CITY OF DETROIT
HISTORIC DISTRICT COMMISSION

NOTICE OF DENIAL AND ORDER

RE: Application Number 00-167; Submitted in Response to a Violation Notice that was Issued for the Unlawful installation of vinyl replacement windows at 1971 Chichago in the Boston Edison Historic District

1971 Chicago, c. 1998

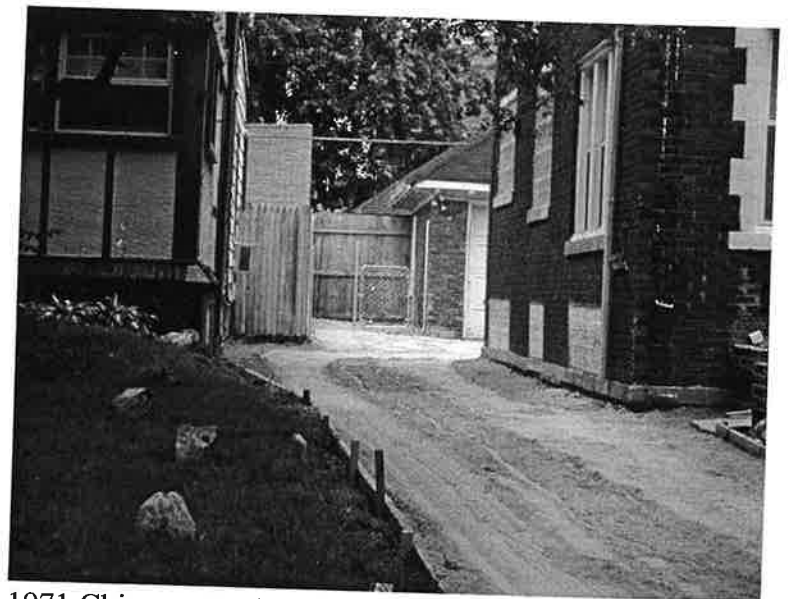
This application was written in response to a violation letter dated April 20, 2000, the work has been completed. The applicant has replaced original wood windows with vinyl replacement windows. The original windows were four over four double hung painted yellow. The replacement windows are one over one white vinyl. The attic windows were not replaced.

The replacement of original windows with vinyl windows, particularly when the windows have muntins, does not meet the standards. I recommend the Commission deny the application and order the windows returned to wood windows to match the original. The work does not meet "The Secretary of the Interior's Standards for Rehabilitation and Guidelines for Rehabilitating Historic Buildings" standard number 6, "Deteriorated historic features shall be repaired than replaced. Where the severity of deterioration requires replacement of a distinctive feature, the new feature shall match the old in design, color, texture, and other visual qualities and, where possible, materials. Replacement of missing features shall be substantiated by documentary, physical, or pictorial evidence."

Pursuant to MCL 399.205(12) and Section 25-2-10 of the 1984 Detroit City Code, the Commission hereby **orders a remedy to duplicate the original muntin pattern on the vinyl windows or the windows returned to wood to match the original.** The replacement and/or reconstruction of this significant architectural feature will bring your property at 1971 Chicago, into conformance with the historic character of the neighborhood, as defined by the remaining buildings in the Boston Edison Historic District.
